TOWN OF TRENTON
DRAFT of Official Minutes

Draft of the Official minutes of the regular meeting of the
Town of Trenton Plan Commission held on
Monday, April 14, 2025, at 7:00 PM at the Town Hall, 1071 State Highway 33 East.

Plan Commission Metal Accessory Structure Architectural Approval – 6924 Beck Ln**Old Hickory Buildings, LLC - IMAGE SHEET Reference #: 2824565**

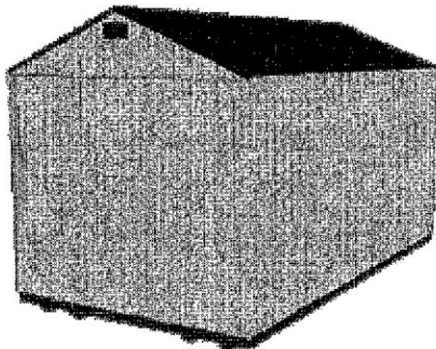
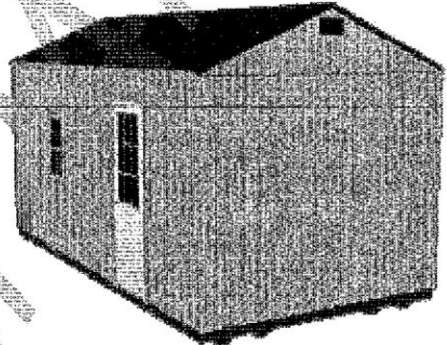
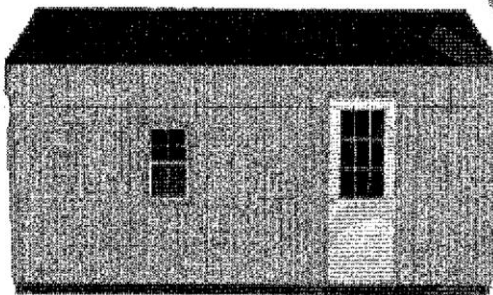
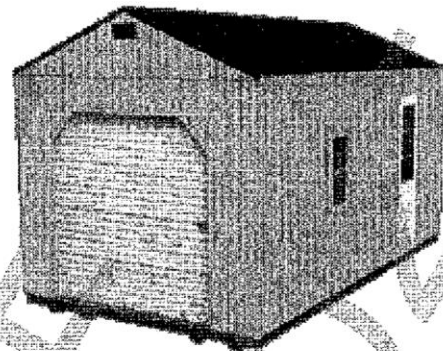
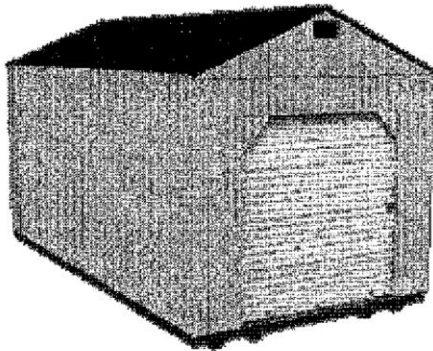
224 sq ft garden shed to be placed within garden area to store tools and supplies
Within limits of 800 sq ft (up to two structures)
Landscaping not applicable because it will be surrounded by garden plants
RECOMMEND APPROVAL
